RE: Response to Comments
The Aurora Highlands PA-58 Neighborhood Park – Site Plan and Final Plat
2024-6011-00; 2024-3016-00

THE AURORA HIGHLANDS SUNSET PARK SITE PLAN

TITLE: COVER SHEET

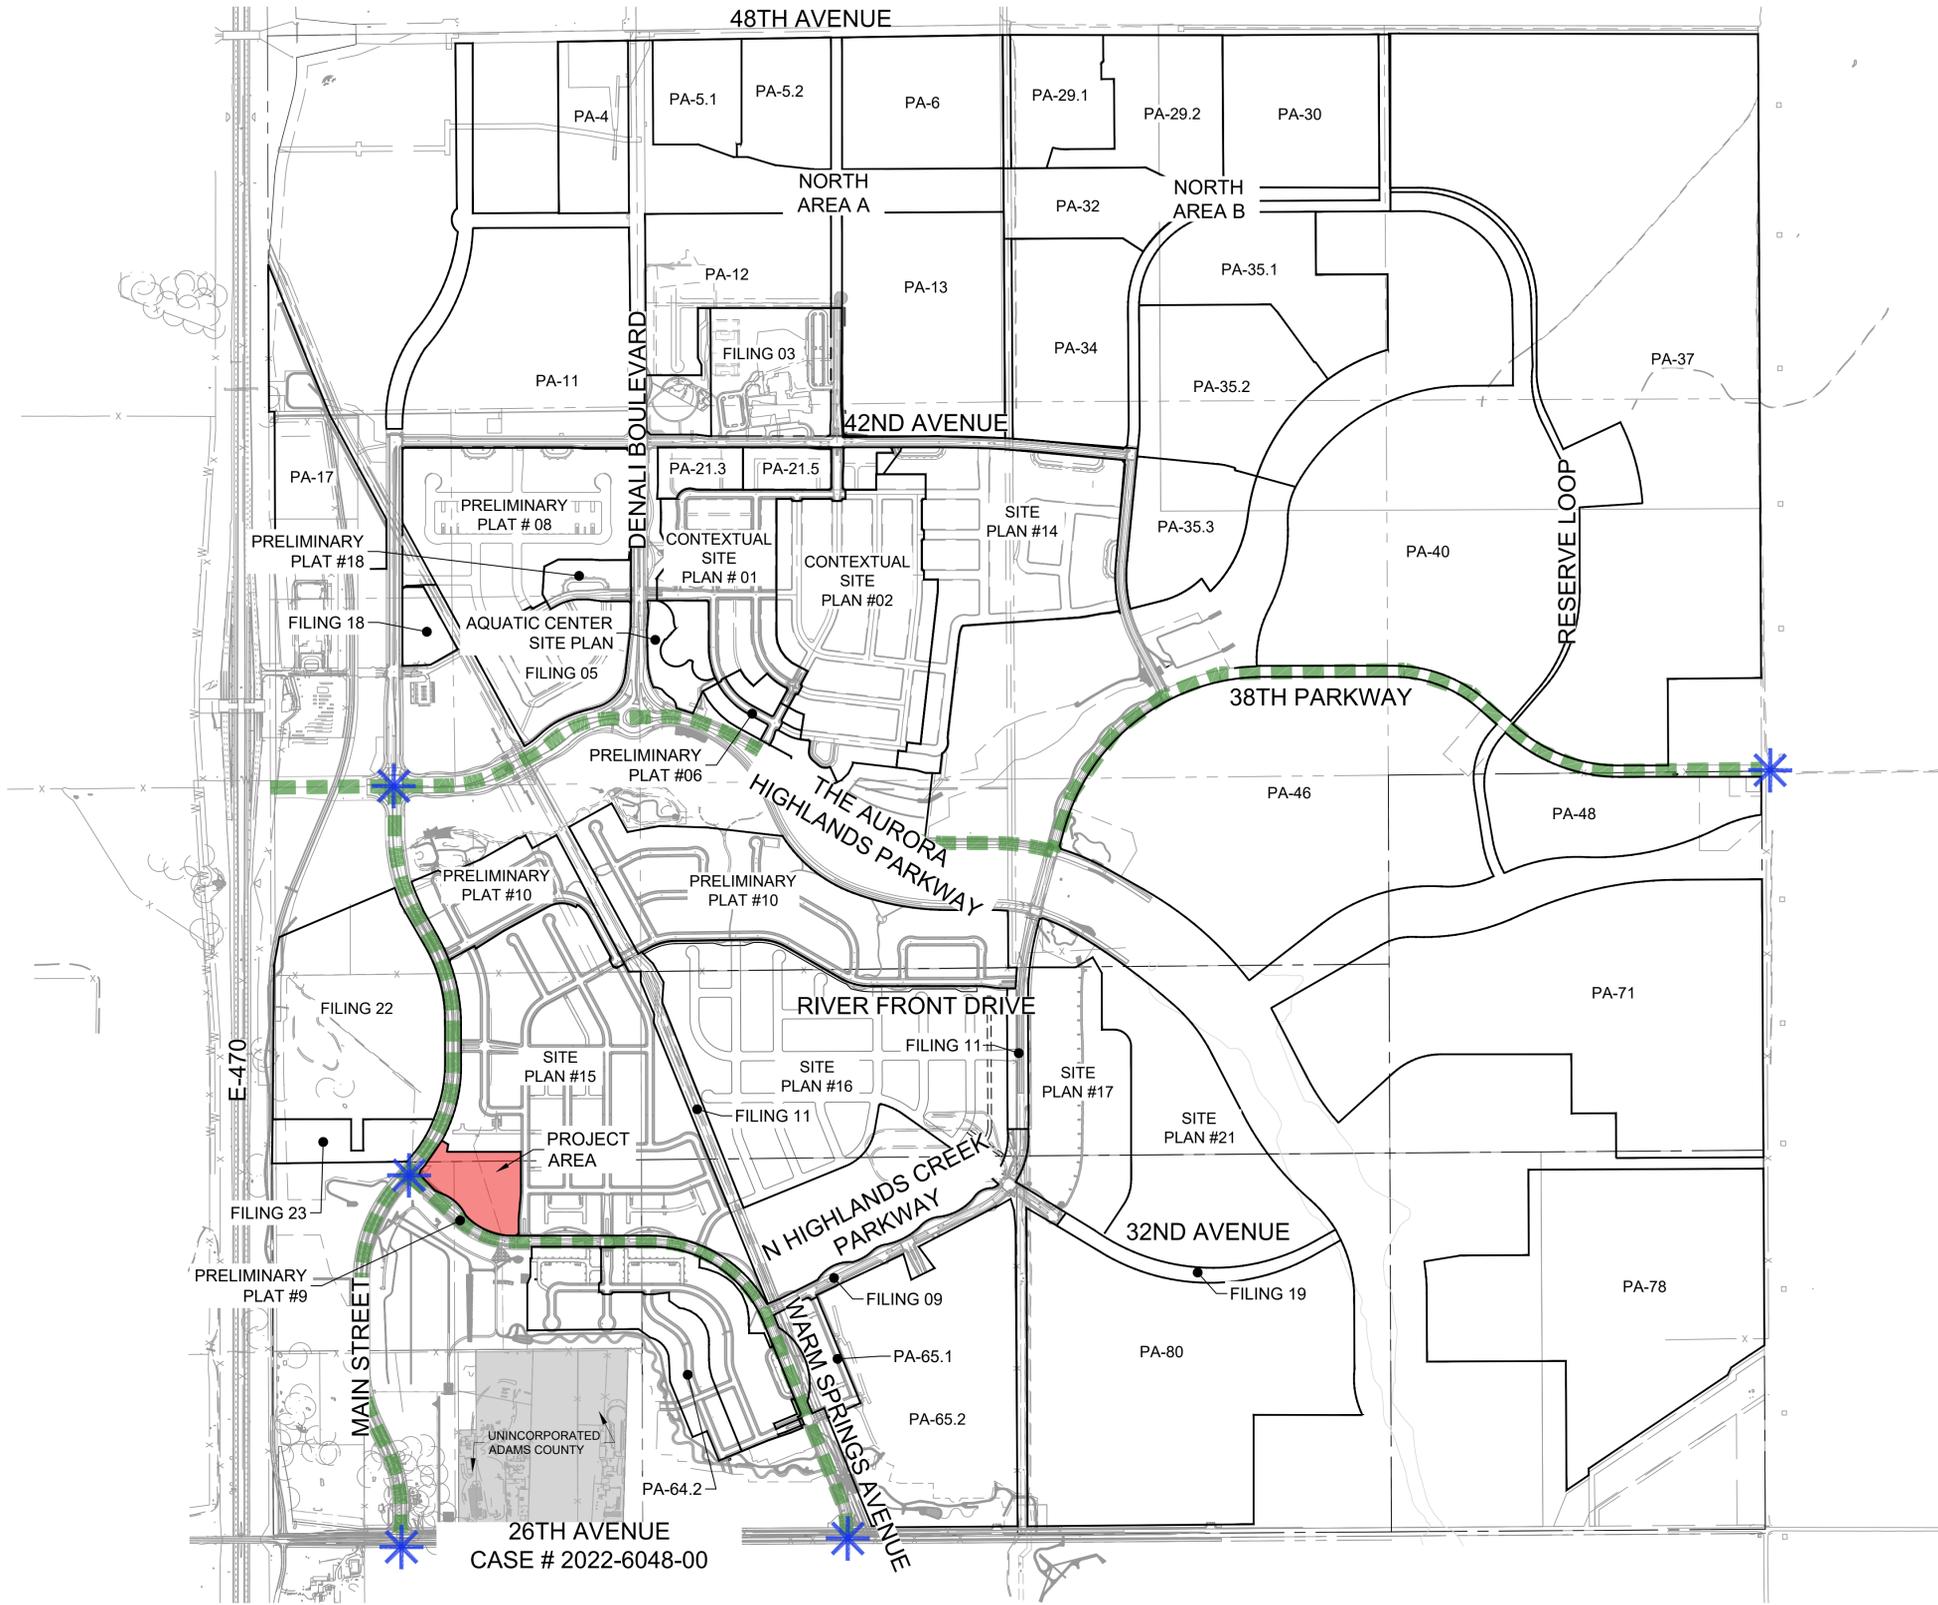
3A. Sheet #1: Check with Land Development Services if the legal description can reference Tract A of Sub. Filing No. 32.

3B. Sheet #1: Add a line for permitted and proposes signage in the Site Data Block.

check with Land Development Services - If the legal description can reference Tract A of Sub Fig No. 32 ?

SITE PLAN DATA BLOCK	
SITE DATA	
LAND AREA WITHIN PROPERTY LINES	6.87 AC / 299,169 SF
TOTAL NUMBER OF UNITS PROPOSED	0
NUMBER OF STORIES	N/A
MAXIMUM HEIGHT OF BUILDINGS	N/A
PRESENT ZONING CLASSIFICATION	R-2, MEDIUM DENSITY RESIDENTIAL
2015 IRC & 2015 IECC CONSTRUCTION TYPE & CLASSIFICATION R3, SINGLE FAMILY DETACHED (NON-SPRINKLERED)	N/A
AVERAGE RESIDENTIAL DENSITY	0
TOTAL LOT AREA	6.87 AC / 299,169 SF
HARDSCAPE AREA	1.04 AC / 45,254 SF
LANDSCAPE AREA	5.83 AC / 253,915 SF
TRACT/OPEN SPACE AREA	6.87 AC / 299,169 SF
ROAD/ROW AREA	0
Add a line for permitted signage and what is proposed.

Response: The legal description has been updated to match the description from the plat that is being submitted.

Response: Permitted and proposed signage has been added to the Site Data Block.

The legal description has been updated to match the description from the plat that is being submitted.

A line has been added for permitted/proposed signage.

SHEET : 3

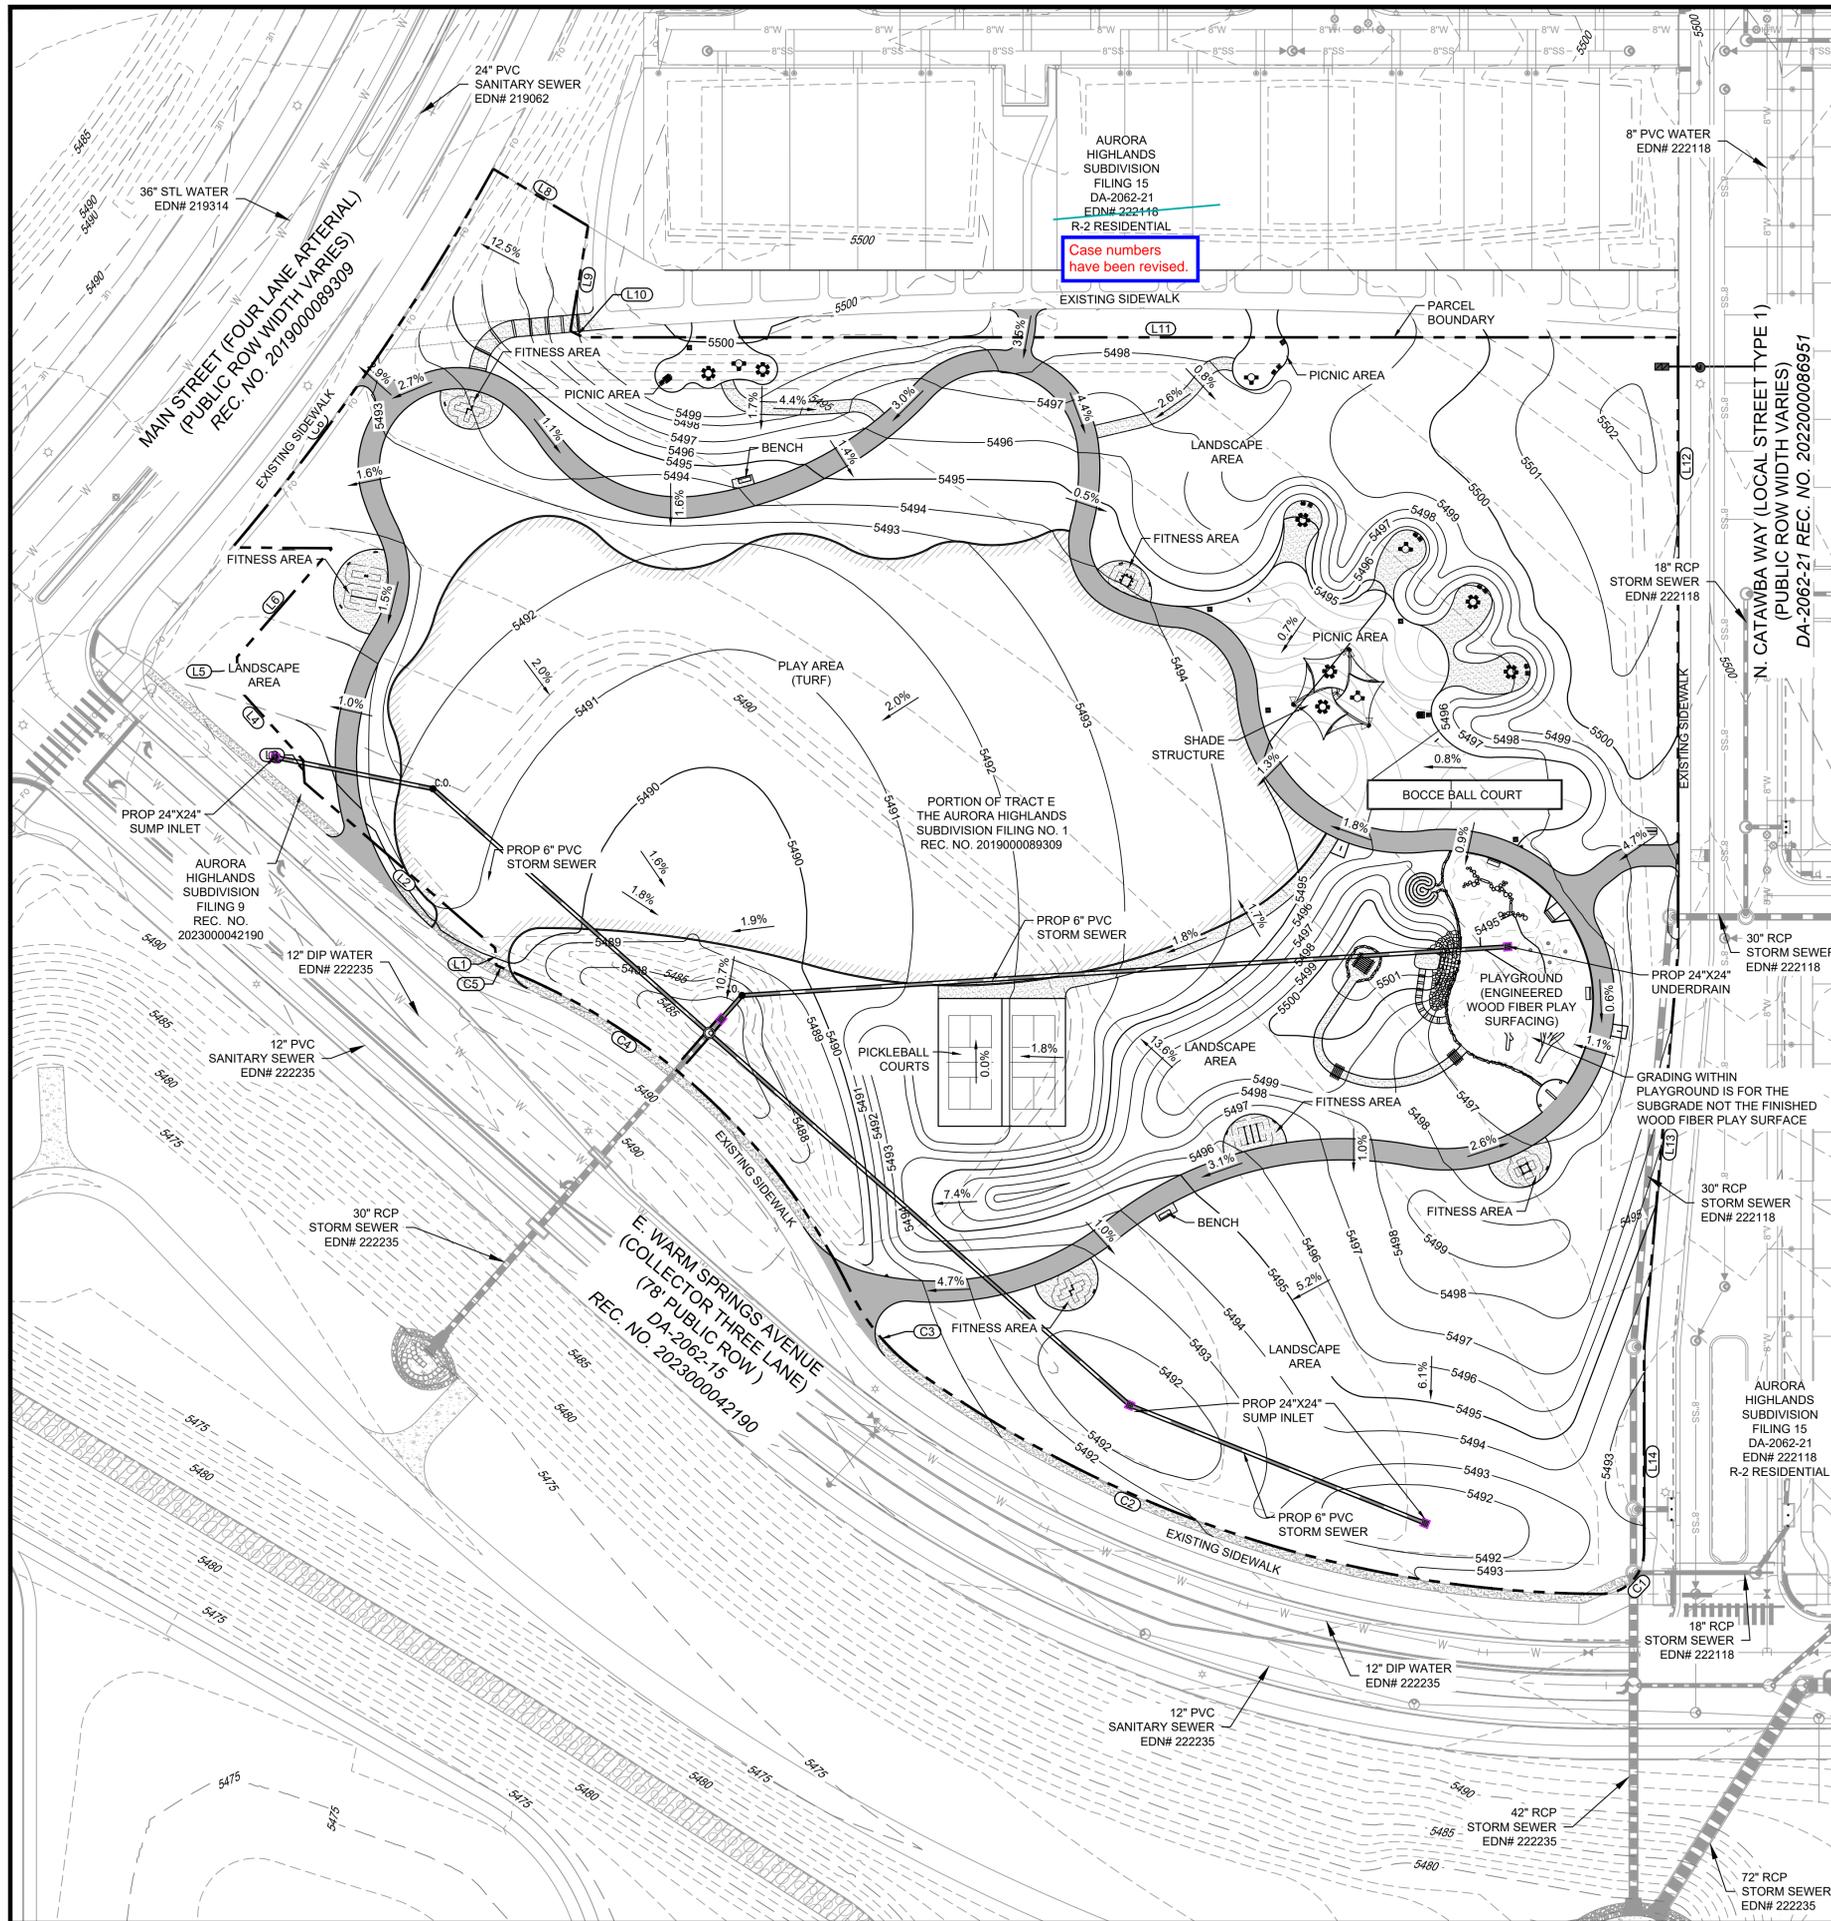
5A. SP Sheet #3: Will the pickleball courts be fenced? If so, include a detail and show the fence location in the pickleball detail.

8A. SP Sheet #3: Please provide a note that identifies the requirement of a separate building permit through the building division will be obtained prior to any construction for both the restroom and the shade shelter.

8B. SP Sheet #3: Please work with the Planning Dept. to identify any addressing needs for this project. (Philip Turner – pcturner@auroragov.org or 303.739.7271).

10A. SP Sheet #3: Active recreation uses and facilities shall be locate a minimum of fifty feet (50') from single-family lots to lessen impacts to such residential areas.

Please work with the Planning Dept. to identify any addressing needs for this project.

Please provide a note that identifies the requirement of a separate building permit through the building division will be obtain prior to any construction for both the restroom building and the shade shelter.

Response: Pickleball courts are intended to be informal and will not be fenced. The berm and landscaping around the south end of the court is intended to help keep balls from going out to the street.

Response: Note has been added to the detail for the shade structure. There is no restroom.

Response: We have contacted Philip Turner to identify addressing needs, which is now in process.

Response: Per our discussion, the picnic areas on the north side of the park are not considered to be active recreation uses.

A note has been added to the shade structure detail.

TITLE: LANDSCAPE PLAN
 DATE: JUNE 2024
 PREPARED BY:
Matrix
 Excellence by Design
 707 17th Street, Suite 3150
 Denver, Colorado 80202
 P 303.572.0200
 www.matrixdesigngroup.com

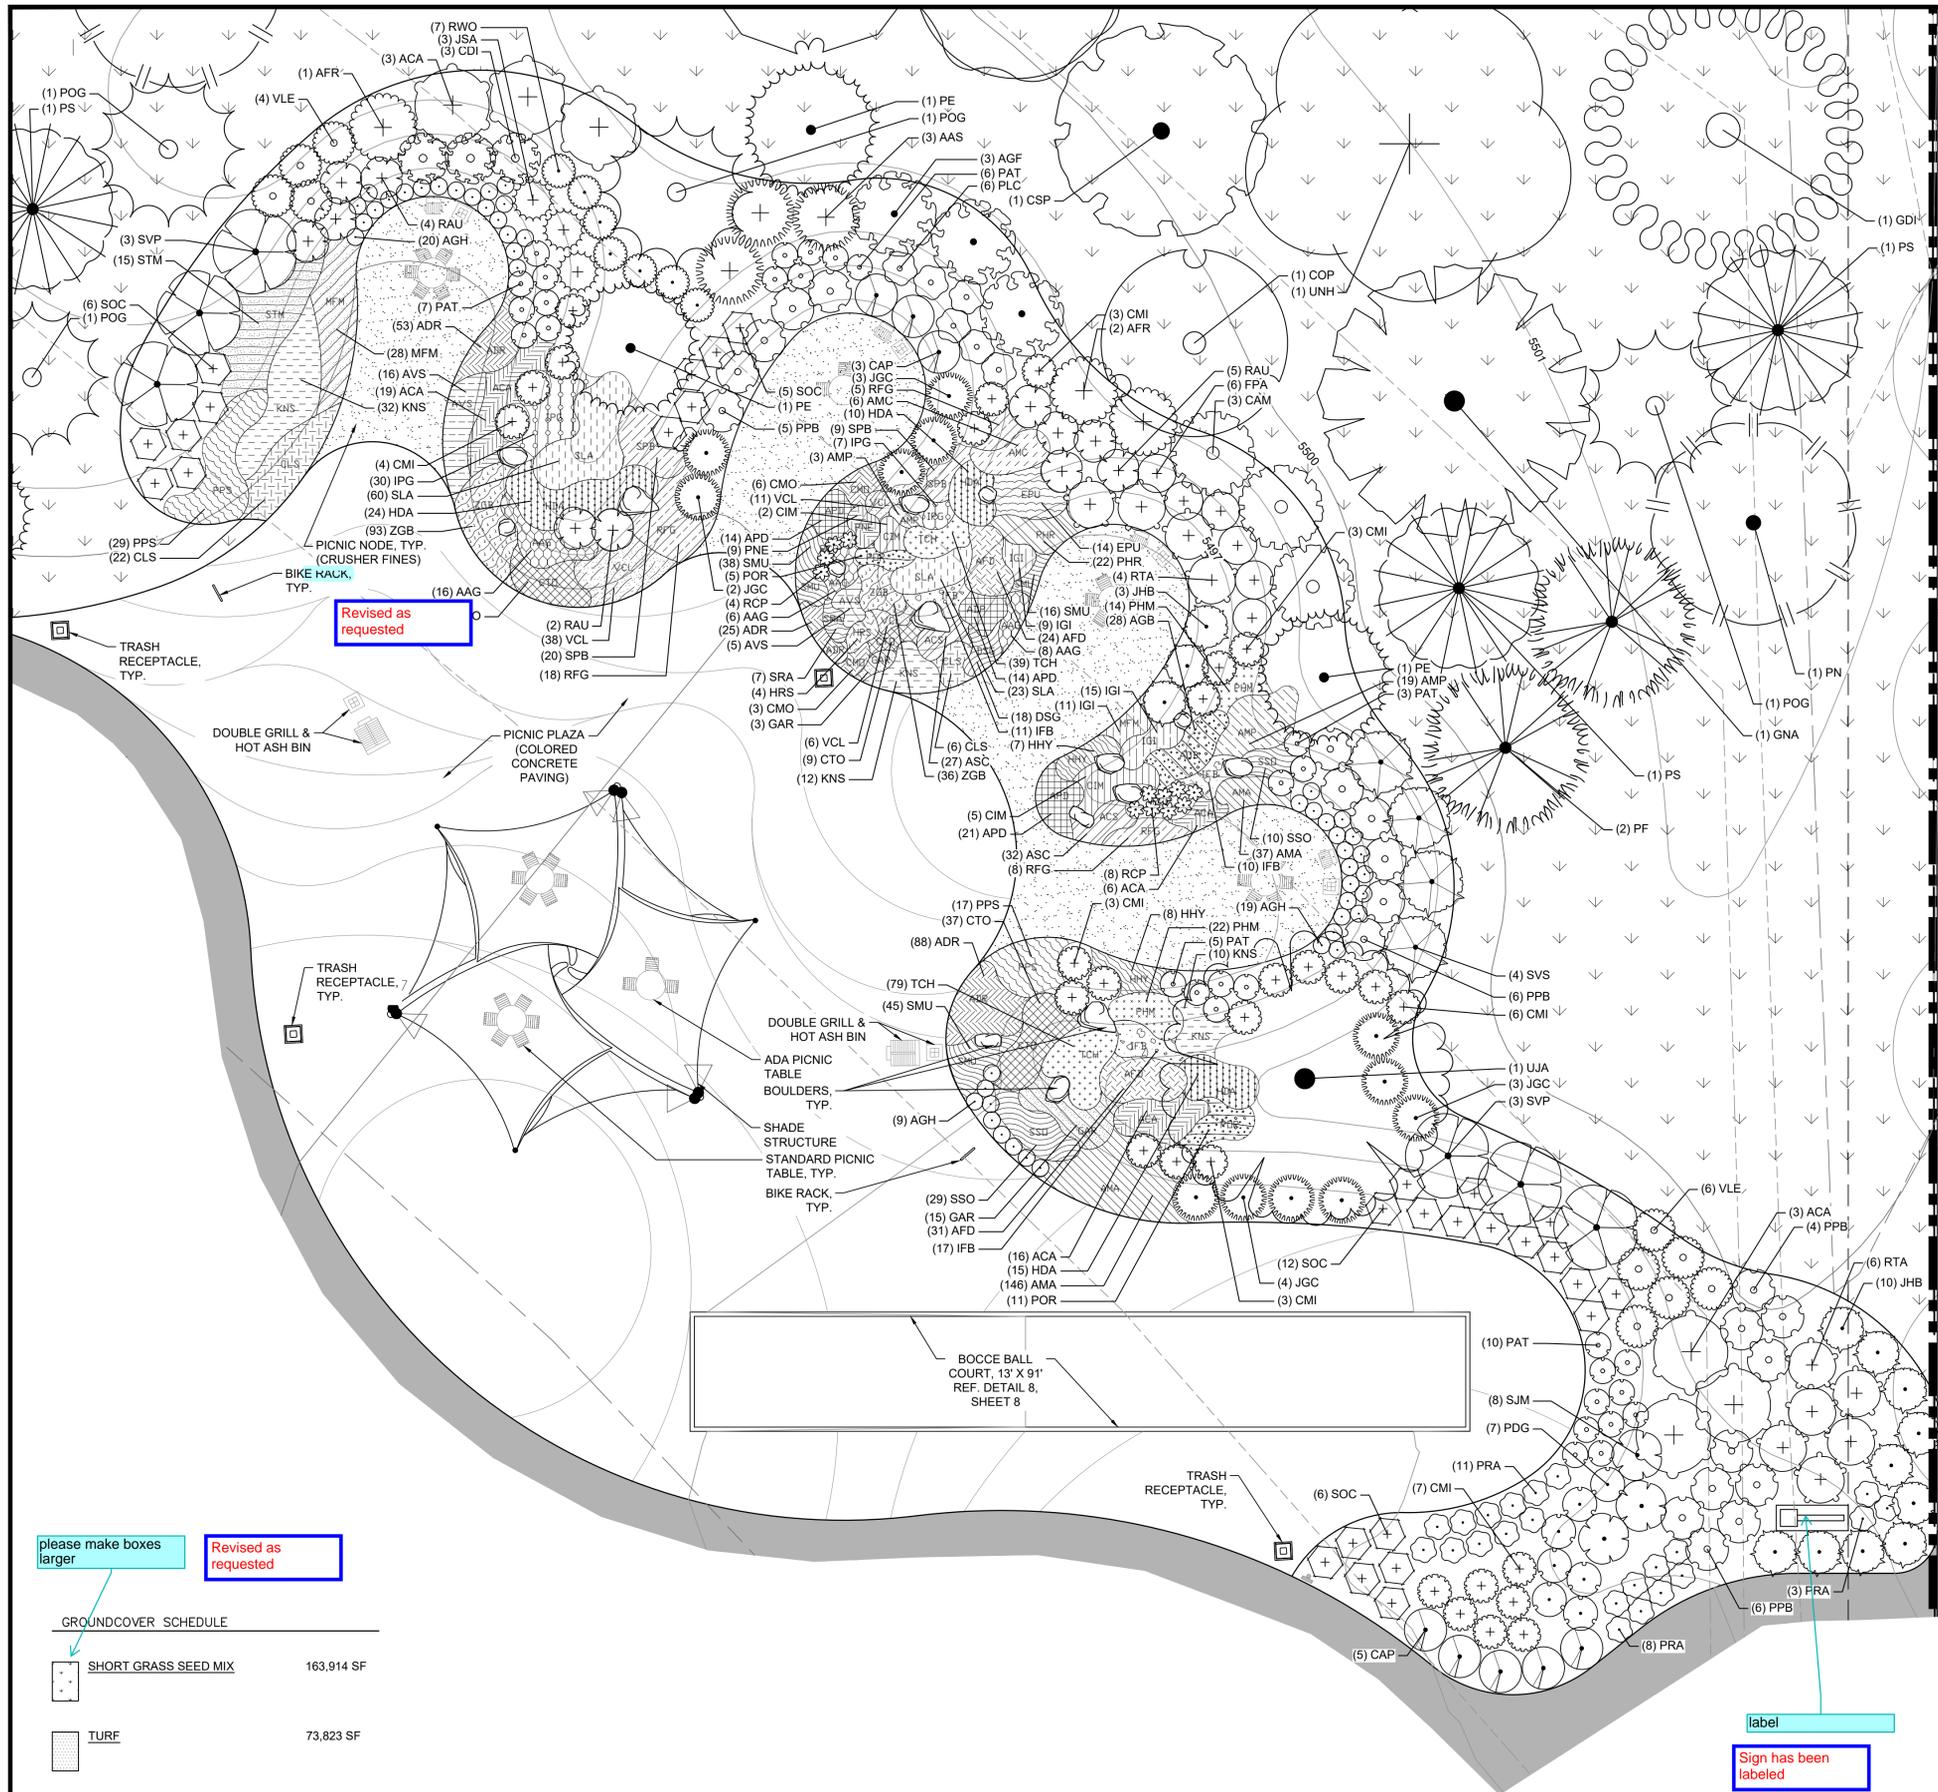
5B. SP Sheet 5: The plans should be coordinated with the landscape provided at the corner of Main Street and Warm Springs Ave. included in Preliminary Plat #9.

5C. SP Sheet #5: Revise case numbers of adjacent site plans.

5D. SP Sheet #5: Please increase the size of the groundcover symbol boxes so the hatches are more readable.

5E. SP Sheet #5: Identify linework. It's not shown on the plat. Label or remove.

10B. SP Sheet #5: Please show where 19 and 20 will be located. They should include an accessible surface and be in the play area.

10C. SP Sheet #5: Please include information showing that the overlook path is ADA-accessible.

what is this linework? It's not shown on the plat. Label or remove.

Please show where 19 and 20 will be located, they should include an accessible surface and be in the play area.

Response: Landscape provided at the corner of Main Street and Warm Springs is now included on the Landscape Plan (shaded back).

Response: The case numbers of adjacent site plans have been revised.

Response: Groundcover symbol boxes have been enlarged as requested.

Response: Linework has been removed.

Response: They are labeled on the Site Plan and the Landscape Plan,, and are located on a concrete pad at the south corner of the play area.

Response: Overlook Path is accessible with slopes not exceeding 4.5% (labeled).

Case numbers have been revised.

Plans have been revised to coordinate with landscape from PP#9, shown screened back

Revised as requested

Labels and grades have been added to make it clear that the overlook is ADA compliant

Case numbers have been revised.
